Application No.: 09/753,764  
Amendment dated: April 13, 2005  
Reply to Office Action Dated: January 13, 2005

### **REMARKS/ARGUMENTS**

### **AMENDMENTS TO THE DRAWINGS**

FIG. 3

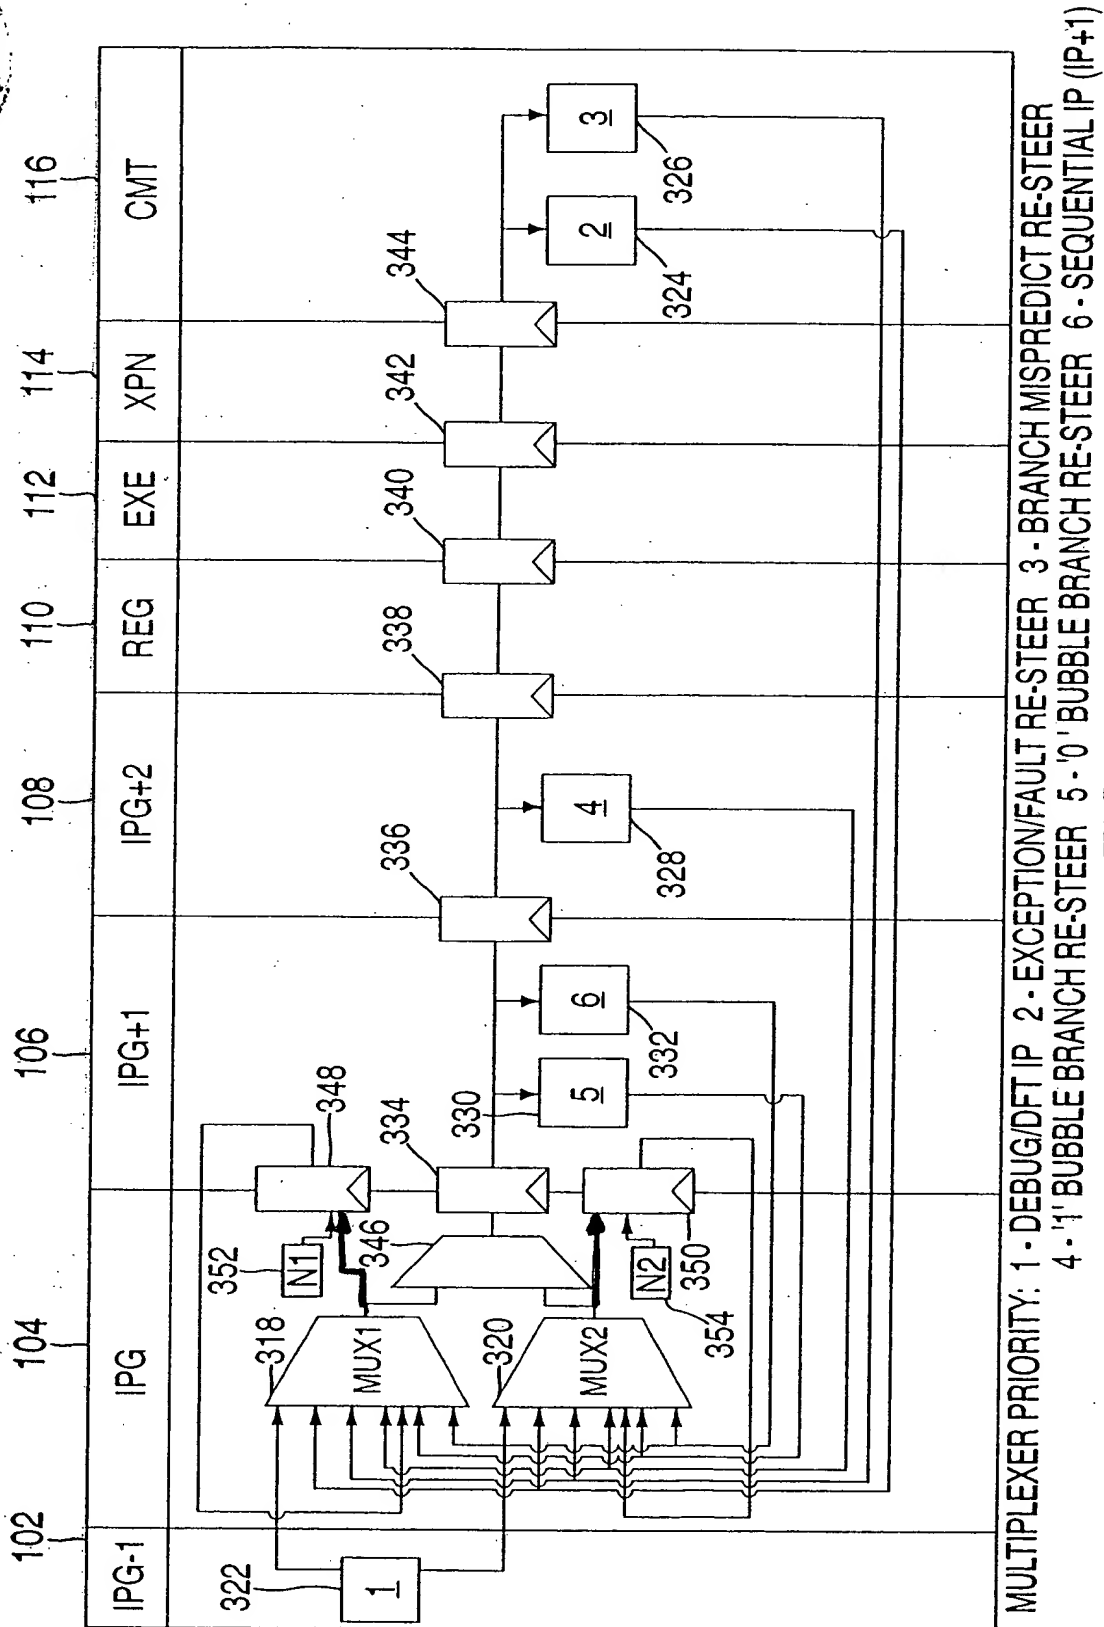
The attached sheets of drawings include changes to Figure 3. Connecting arrows pointing from multiplexer 318 to storage element 348 and from multiplexer 320 to storage element 350 have been reintroduced to Figure 3. These connecting arrows were present in Figure 3 as originally filed, but were accidentally left off the formalized drawings.
